OUR REF: 18005

4 June 2021

**RESPONSE TO COUNCIL ASSESSMENT REPORT
NOS. 19-27 CROSS STREET, DOUBLE BAY (DA 321/2020)**

Figure 1: 3D View of Building Envelopes (Blue = DCP, Orange = Approved/Existing)

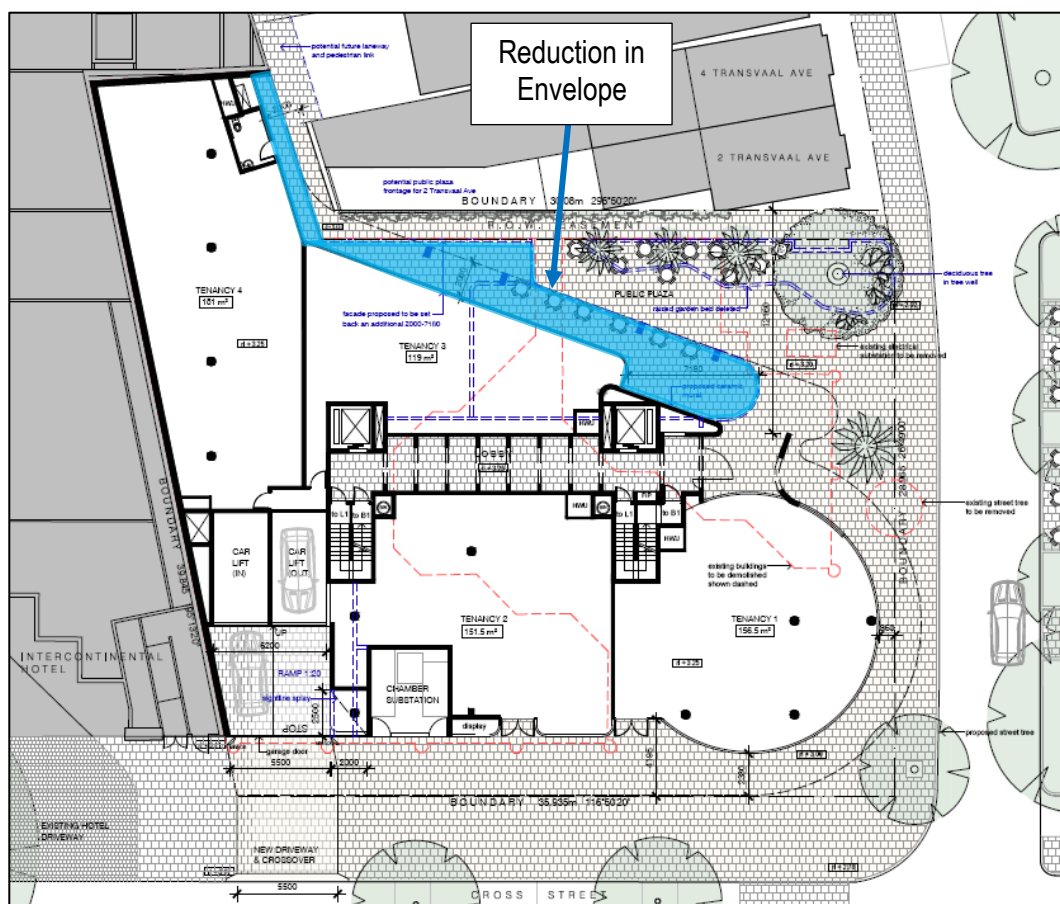
The report prepared by Atlas Urban includes a figure showing the 3D view of building envelopes as per the DCP requirements, and envelopes as approved and existing (see **Figure 1** on the following page). This demonstrates various departures in the existing and approved built form along Cross Street in comparison to the strict building envelopes envisioned by the numerical controls of the DCP, and height in the LEP.

Figure 2: Ground Floor Plan Showing Original and Proposed Envelope

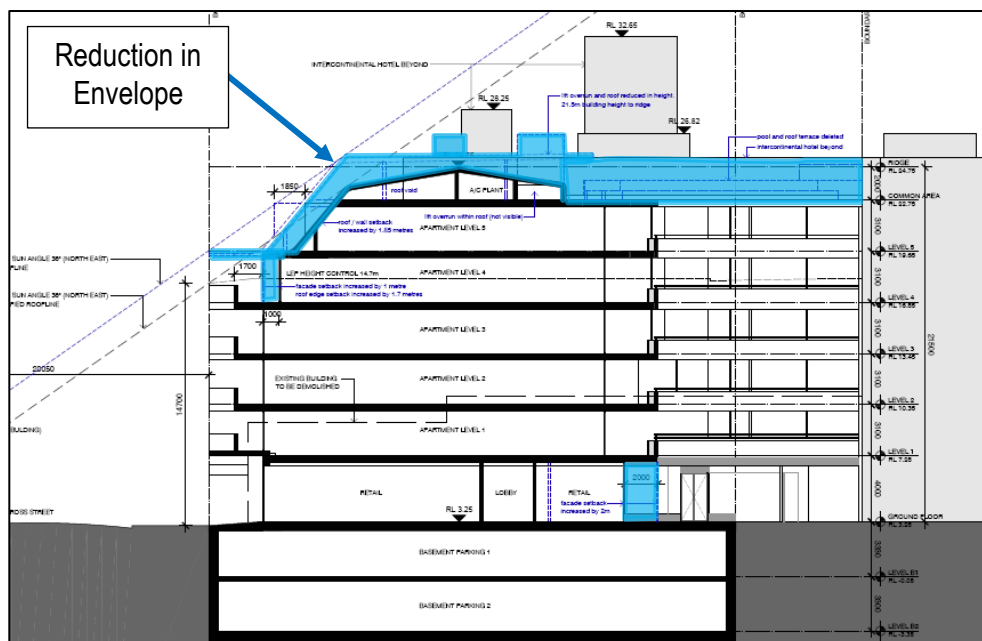
The proposal has been supported by a Heritage Impact Statement, and an updated Heritage Response prepared by John Oultram Heritage and Design. This material has been reviewed, and an accompanying Heritage Peer Review has been prepared by Urbis in support of the proposal. Council's key concern was the proposal having an unacceptable adverse impact on the heritage significance of the Transvaal Avenue HCA.

As discussed in Section 1.0 of this letter, and in the accompanying Heritage material prepared by John Oultram and Urbis, the proposed design will have a more positive outcome on the HCA in comparison to a built form that strictly complies with Council's controls. It is highly unlikely that a compliant solution would have any positive outcomes on the HCA compared to the amended scheme. The effect of the proposed building setback and rounded forms provides more direct views from and of Transvaal Avenue, and will act as a gateway to the HCA. The amended scheme increases the northern building setback from the adjoining terrace, to 'open up' the space and provide improved viewlines to the adjoining terrace and HCA, in comparison to a DCP compliant envelope (see **Figure 2**). It also provides sleeving to the unattractive blank wall of the Intercontinental Hotel addressing Transvaal Avenue, behind the terraces.

Figure 4: Aerial View Showing Height of Development in the Double Bay Centre

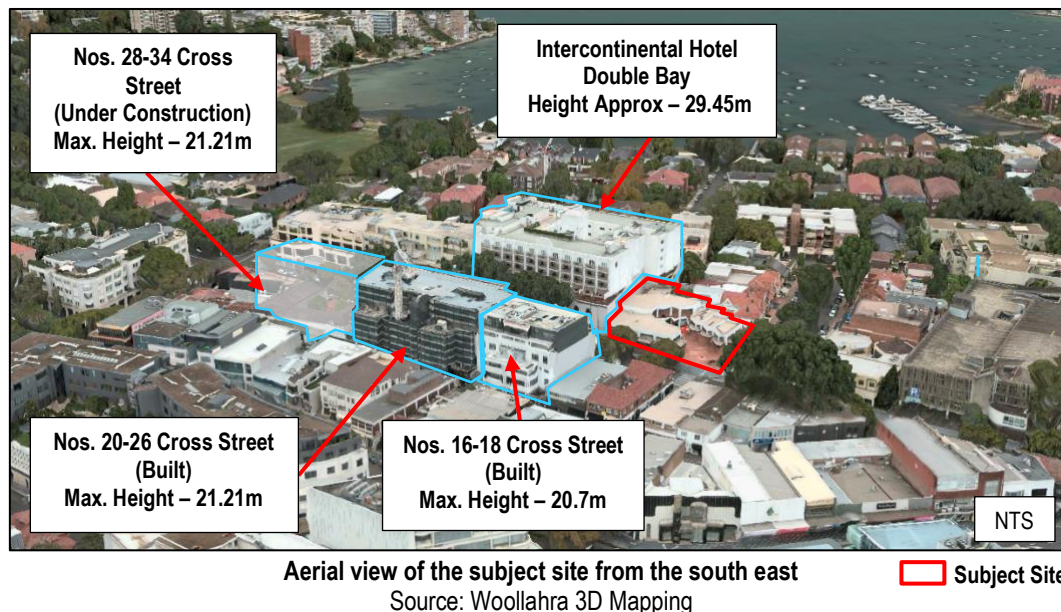
The proposed height is similar to recent approvals on Cross Street such as Nos. 16-18 Cross Street, Nos. 20-26 Cross Street and Nos. 28-34 Cross Street; and is significantly less than the InterContinental Hotel Double Bay, located adjacent to the site (see **Figure 4** on the following page).

Figure 6: Aerial View Showing Scale of Development in the Double Bay Centre

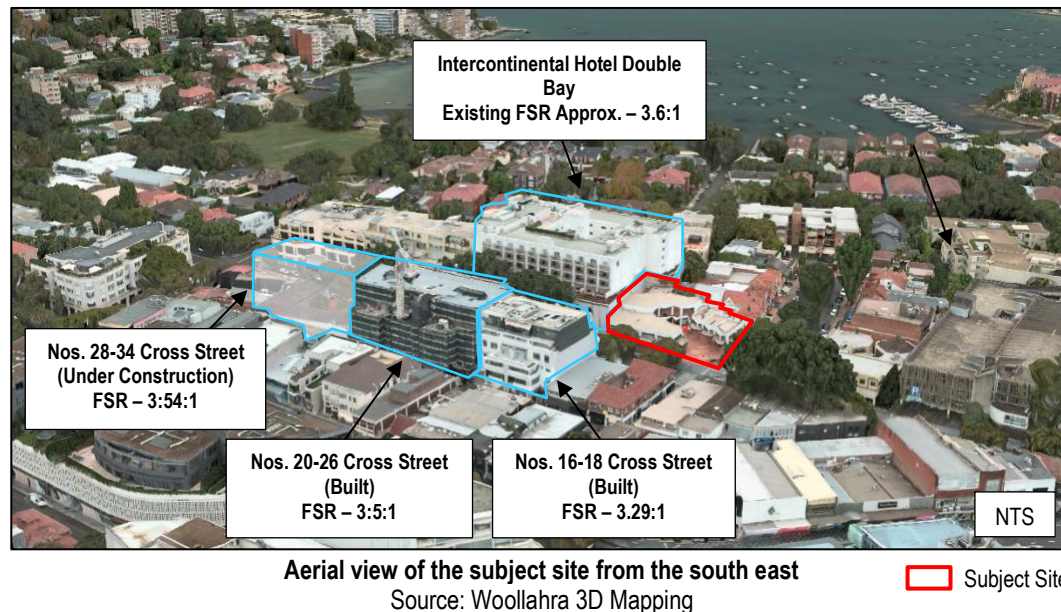
Council's assessment states that the DA is excessive in bulk and fails to comply with the FSR development standard. As discussed in the Clause 4.6, the LEP prescribes a maximum FSR of 2.5:1 which amounts to a maximum GFA of 3,335m². In response, the proposal has been amended to reduce the overall extent of the building with a reduction of 136m² from 4,796m² as originally proposed, to 4,660m² as amended. The departure from the FSR standard is appropriate in the context as it is similar to recent approvals in the area such as Nos. 16-18 Cross Street, Nos. 20-26 Cross Street and Nos. 28-34 Cross Street; significantly less than that of the InterContinental Hotel; and will provide sympathetically-designed retail and residential space (see **Figure 6**).
